SPRINGS HILL WATER

RE: Addendum #1 – Comments on SCTRWPG Initially Prepared Plan

Figure 1

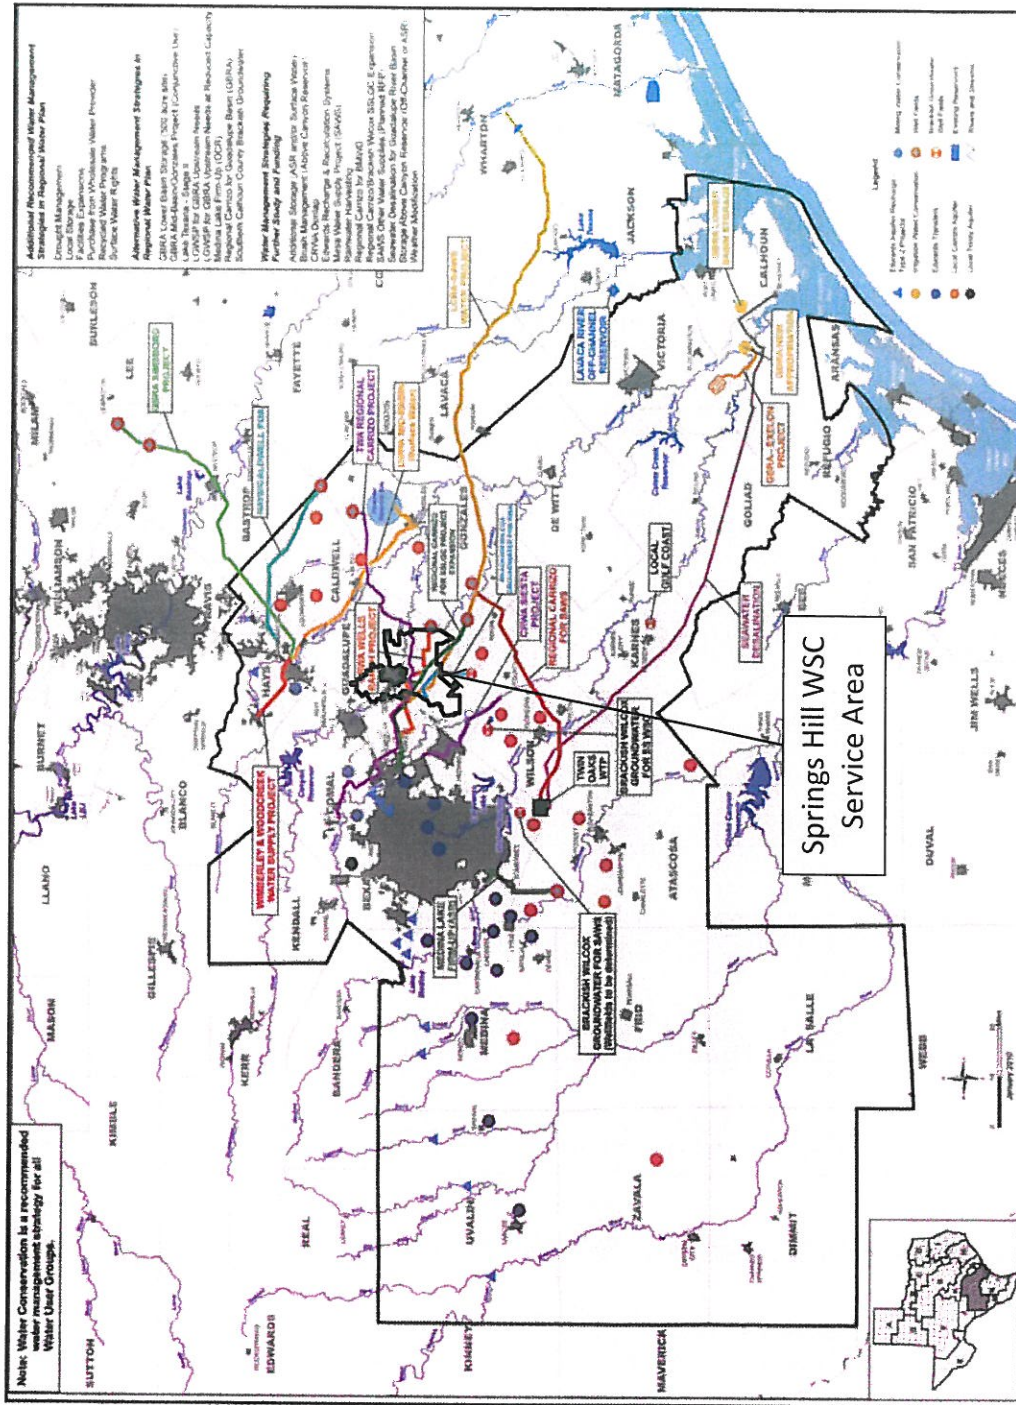
The only intent of the SHWSC comments is to recommend that the IPP adopt a regional solution to the conveyance of water from areas of water availability (generally located to the east and south of the SHWSC service area) the areas of greatest water demand (generally located in Bexar, Guadalupe, and Comal Counties). The SHWSC service area is located in between these two areas as shown in Figure 1.
